**RESOLUTION HOLDING HEARING REGARDING REQUEST FROM STONEY POINTE CAR WASH, LLC (OWNER), REPRESENTED BY LLOYD D. LINN (OFFICER), FOR REVIEW AND APPROVAL OF A 2<sup>ND</sup> AMENDMENT TO THE STONEY POINTE PUD CONCEPTUAL PLAN, ON PROPERTY LOCATED AT 5901 SOUTHEAST 14<sup>TH</sup> STREET, TO ALLOW A RESTAURANT WITH A DRIVE THROUGH USE**

June 22, 2022

## **STAFF REPORT TO THE PLANNING COMMISSION**

**A** SITE PLAN  
1" = 20' FT

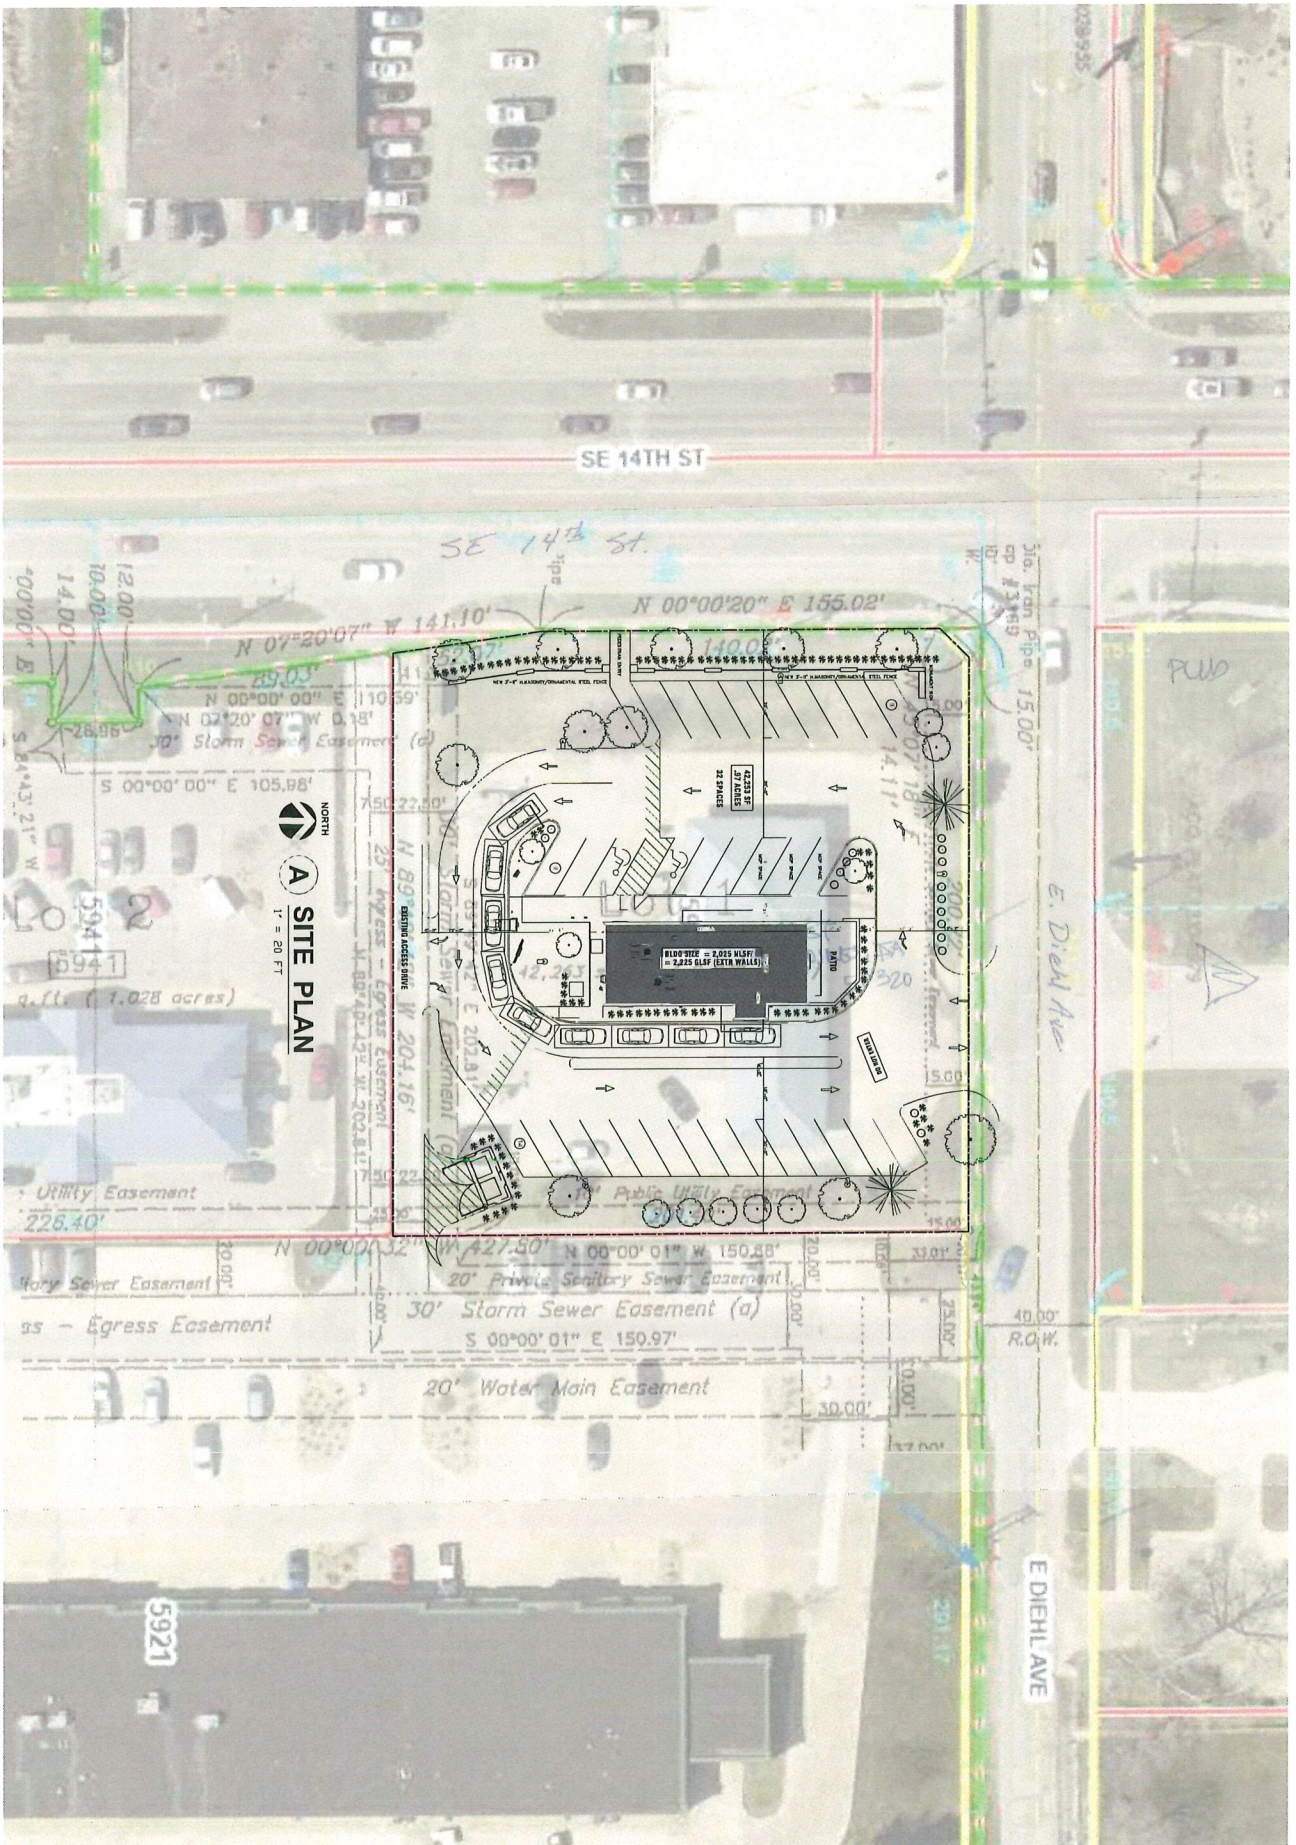
Staff believes the proposed PUD amendment is appropriate so long as the proposed structure engages Southeast 14<sup>th</sup> Street as discussed in Section II, Subparagraph 5 of this report.

4. **Traffic/Street System:** Traffic and Transportation staff have indicated that the proposed amendment will not necessitate any improvements to the surrounding public street.
5. **Urban Design:** The proposed amendment would allow construction of a one-story structure with drive-through facility in place of the existing car wash building. The new building would be centered on the site with a 102-foot setback from SE 14<sup>th</sup> Street and a 55-foot setback from East Diehl Avenue. Access to the site would be through the existing internal driveway on the southern property line and the existing driveway to East Diehl Avenue on the northern property line.

Staff suggests that the westernmost row of parking be shifted to the back side of the building. The landscape strip along SE 14<sup>th</sup> Street could also be slightly reduced. These two changes would allow the building to be shifted 25 feet closer to SE 14<sup>th</sup> Street than what is proposed. This would reduce the number of potential vehicle movements that a pedestrian would have to track as they enter the site from the SE 14<sup>th</sup> Street sidewalk.

The Conceptual Plan shows a proposed monument sign located at the northwest corner of the subject property (SE 14<sup>th</sup> Street and East Diehl Avenue). Staff recommends that any proposed non-building-mounted signage comply with Table 134-5.6-1 and Section 134-5.5.4 which states no more than one 75-square-foot monument sign per street frontage and a base height of at least two feet or 25% of the overall sign height, whichever is greater; a base width at least as wide as the sign face; and a sign base constructed of brick, stone, concrete block, or similar permanent, durable material complementing the exterior of the primary building on the lot.

1. Reduction in the building setback from SE 14<sup>th</sup> Street to the satisfaction of the Planning & Urban Design Administrator.
2. Any proposed signage shall comply with the requirements for the MX3 District.
3. Addition of the following notes on the “PUD” Conceptual Plan:
  - a) Development of the site must comply with the Tree Removal and Mitigation Ordinance contained in Chapter 42, Article X, of the City Code.

1. Reduction in the building setback from SE 14<sup>th</sup> Street to the satisfaction of the Planning and Urban Design Administrator.
2. Any proposed signage shall comply with the requirements for the MX3 District.
3. Addition of the following notes on the “PUD” Conceptual Plan:
  - a) Development of the site must comply with the Tree Removal and Mitigation Ordinance contained in Chapter 42, Article X, of the City Code.
  - b) Any grading is subject to an approved grading permit and soil erosion control plan, as well as a Stormwater Pollution Protection Plan (SWPPP) approved by the Iowa DNR.
